## COMMENTS ON GROUNDWATER DISCHARGE PERMIT

By Charles Judd – October 26, 2009

Thank you for opportunity to comment on the proposed amendment to EnergySolutions Groundwater Discharge Permit (UGW450005). It seems that the permit review has been done in a professional and thorough manner. After our review it has become clear that there are a few other items that should be considered and a couple of small changes that should be made to the permit. These items are listed below:

Attachment 7-6

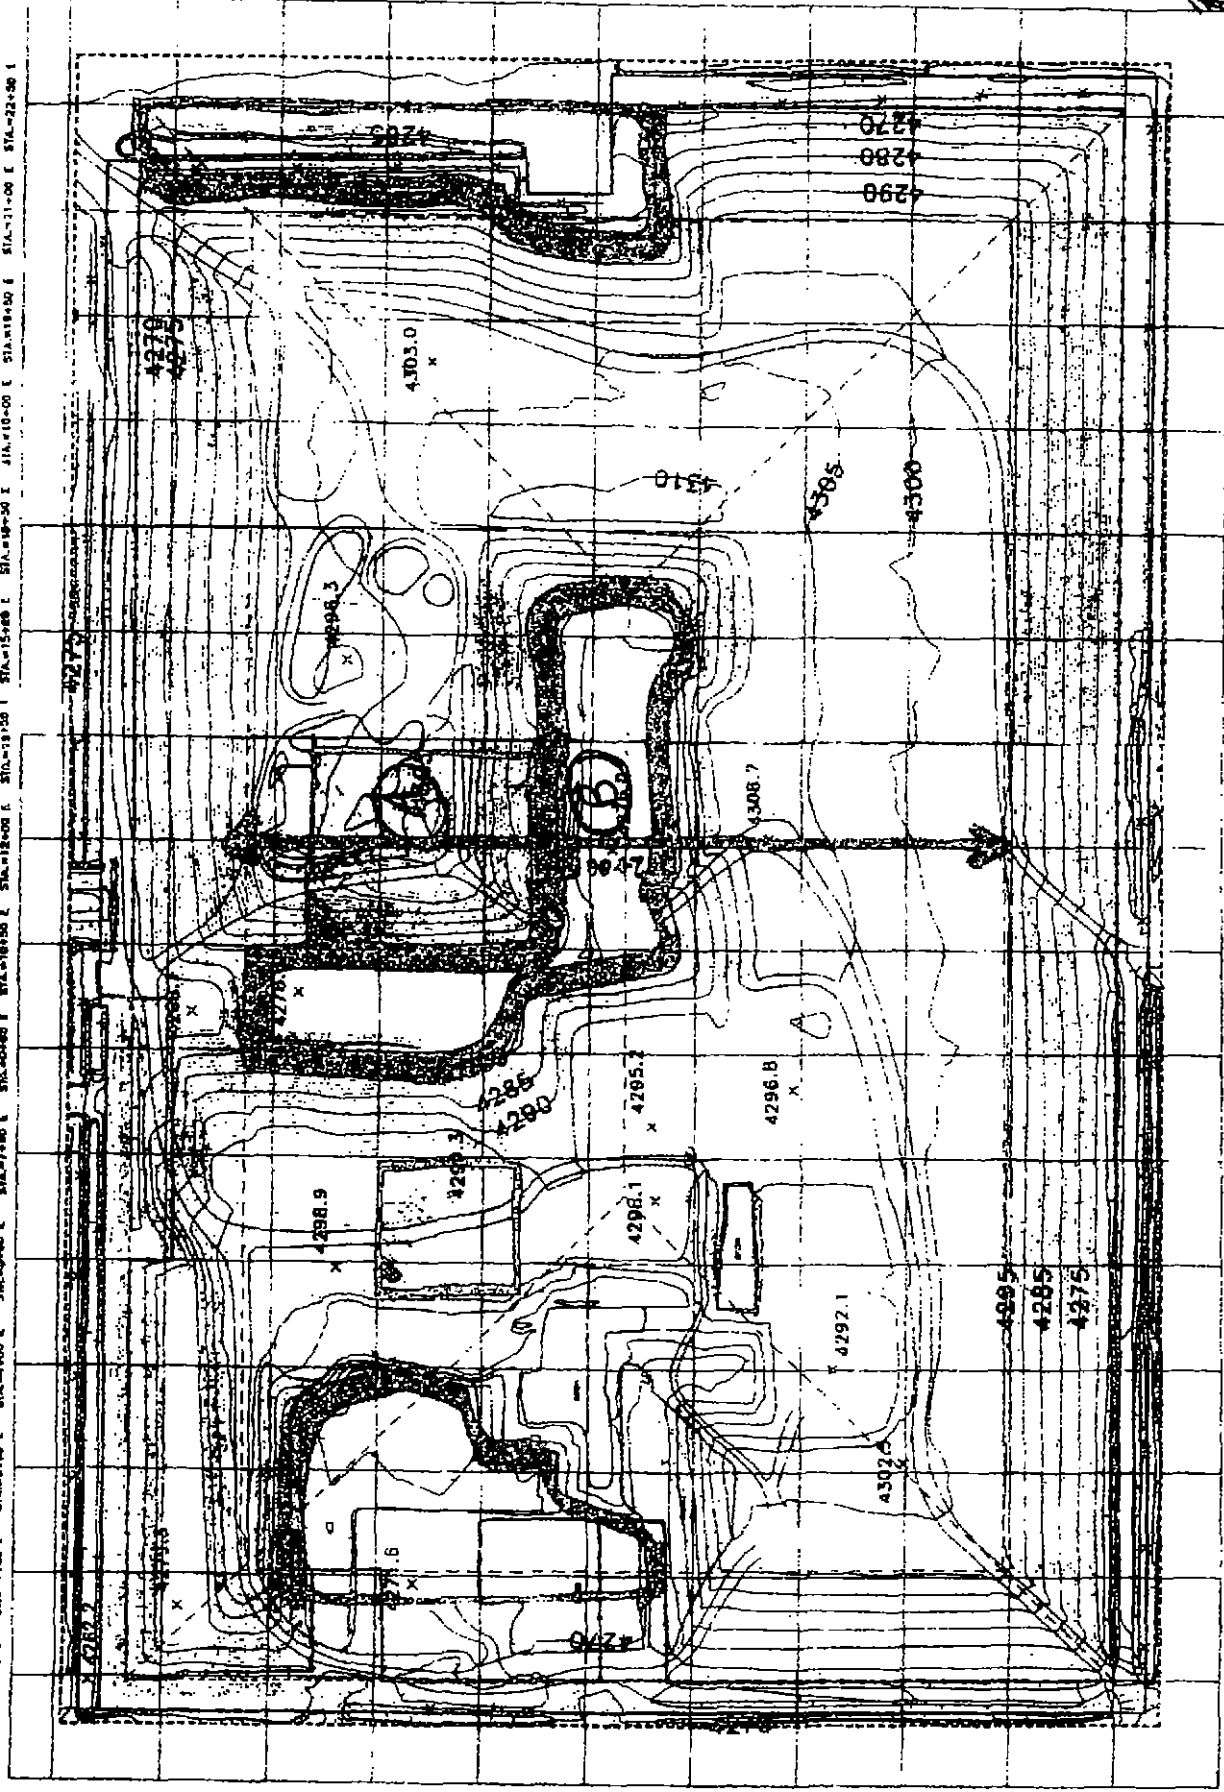
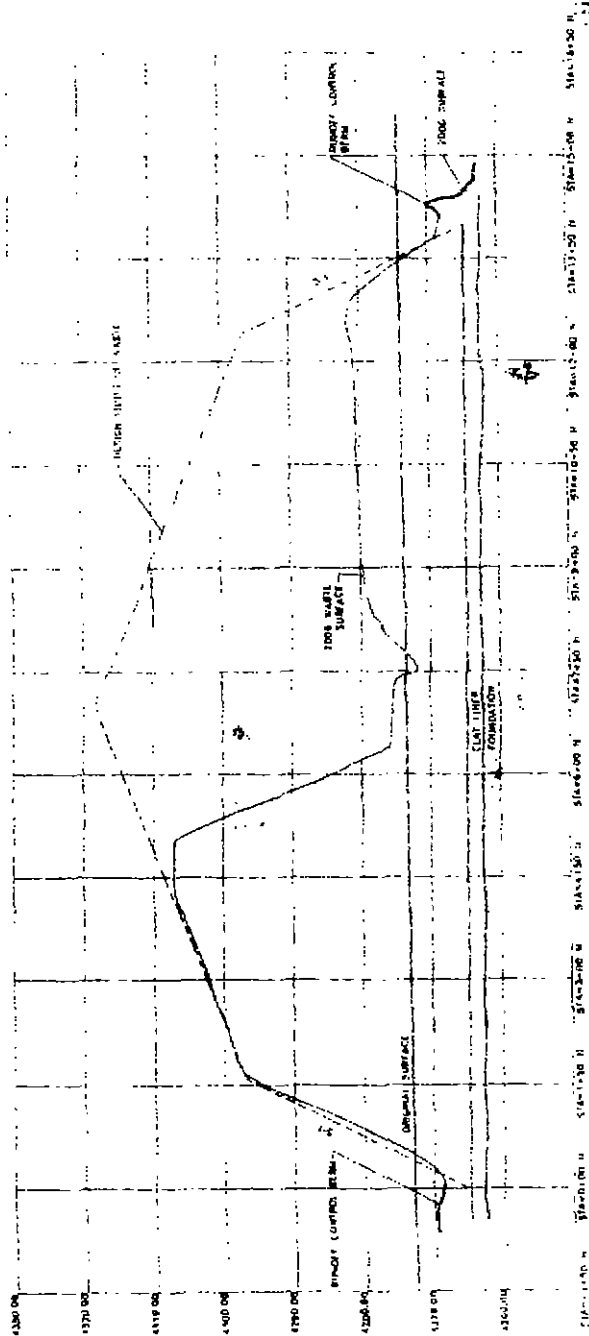
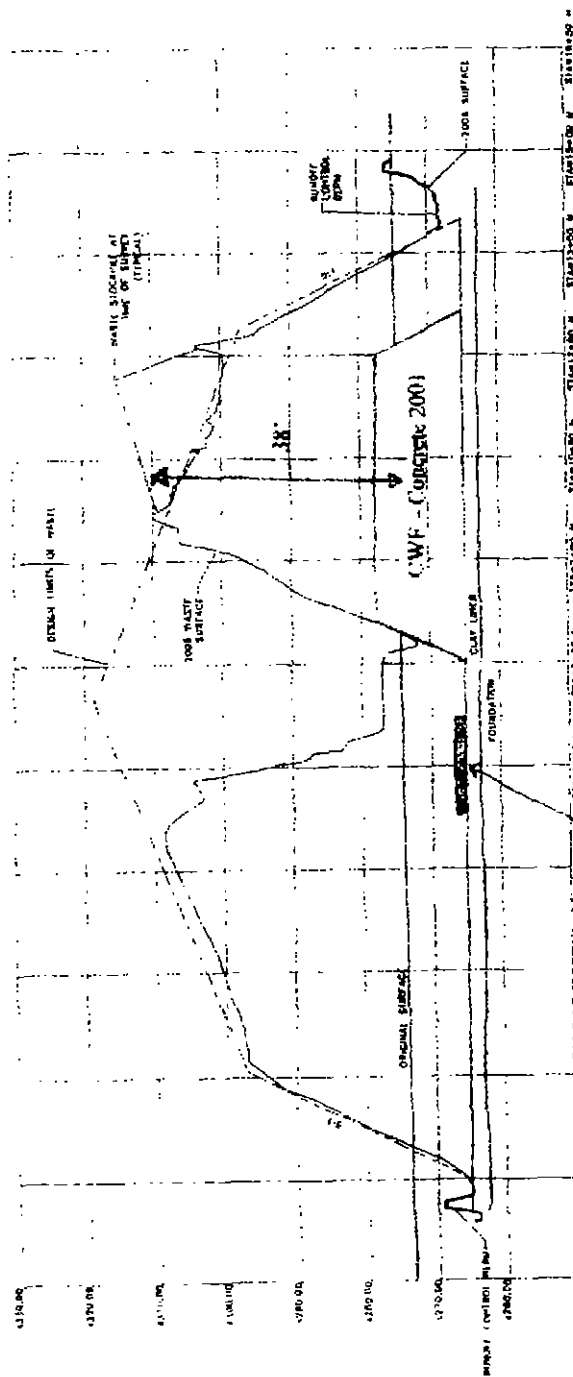
It is expected that we will see an even more dramatic effect from settlement in the Class A cell. Attachment 7-6 shows one of the many areas of concern in the Class A cell. If a line is drawn north and south along what is marked as the STA = 12 + 00 E line one can easily see that there are going to be huge settlement issues. Attachment 7-6(b) shows a cross section of this line. Included with this drawing is the location of H12 which was opened in the year 2000. The cross section also shows the huge concrete block marked as CWF Concrete 2001. One of the first thing that we notice is that the waste placement in this cross section is in direct violation of Energy Solutions permit. Energy Solutions LRA states on page 10 and 11 states "The cut and cover nature of the operation will preclude dramatic differences in waste column height and, accordingly, in settlement with the active embankment. The abnormal condition

considers possible effects of having a section of the embankment completed to cover height with an adjacent area of waste placement less than 25 feet high. ... The low height of 25 feet was chosen because this is the maximum calculated height of the embankment before preconsolidation stress is exceeded; in excess of this thickness, primary consolidation (settlement) begins to occur in the lowest layers of the embankment. This condition represents the maximum potential differential settlement for the liner." In other words the maximum difference in between areas where waste can be placed is 25 feet. Instead, Energy Solutions has constructed the cell with areas where the difference in heights of adjacent waste sections is 38 feet. (See Attachment 7-6 (red areas)).

top of the pile that have encouraged settlement in these random areas instead of areas where it would really be helpful. The surety only has monies for 500 linear feet of surcharge materials even though there are many feet of areas that will really need surcharge when they are brought up to grade quickly. Please note the areas on Attachment 7-6 (red areas) where there are canyons between waste piles.
